Rezoning Transportation Analysis

Petition Number: 2020-099

Date	Description
08-20-20	First Review
09-22-20	Second Review
10-28-20	Third Review (KP)

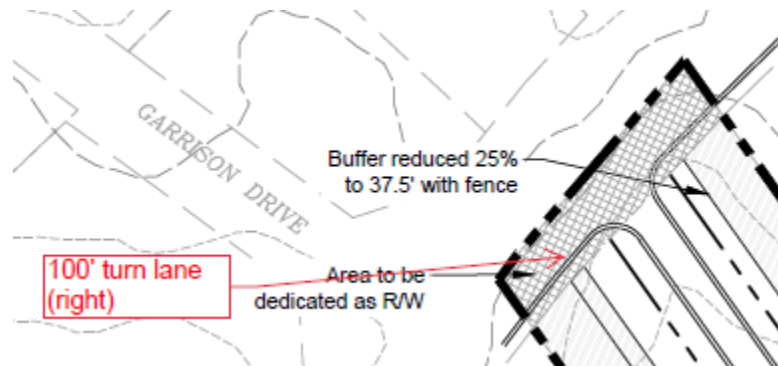
- a. **Technical Clarification (site plan dated 09/14/20)** The petitioner should clarify whether front-loaded or rear-loaded units are proposed. If front-loaded, the petitioner should commit to pair shared driveway aprons with every two units, to preserve the proposed planting strip and sidewalk within the public right of way. This request limits the number of curb cuts, promotes walkability, and preserves a quality streetscape.

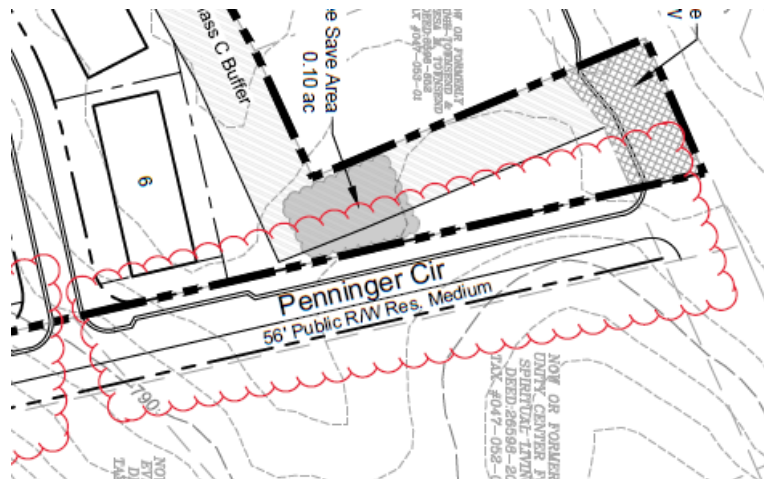
9. ~~The petitioner should remove the proposed access on Mallard Creek Road, as shown below; NCDOT does not support an access at this location of Mallard Creek Road, in reference to the STIP's u-turn bulb-out. Please revise the site plan to provide adequate access for the existing single-family properties, using the proposed USDG Residential Medium/Wide section as proposed below. Please include sidewalk and planting strip on both sides of Penninger Circle.~~

- a. ~~**Technical Clarification (site plan dated 09/14/20)** The petitioner should clarify the site plan to show and call-out the existing Penninger Circle private drive that ties into existing Mallard Creek Road. CDOT requests the petitioner to clarify that the existing Penninger Circle road improvements will be constructed in accordance with CLDSMU-02 - Local Residential Medium Section cross section design standards, on both sides of the existing Penninger Circle road centerline.~~
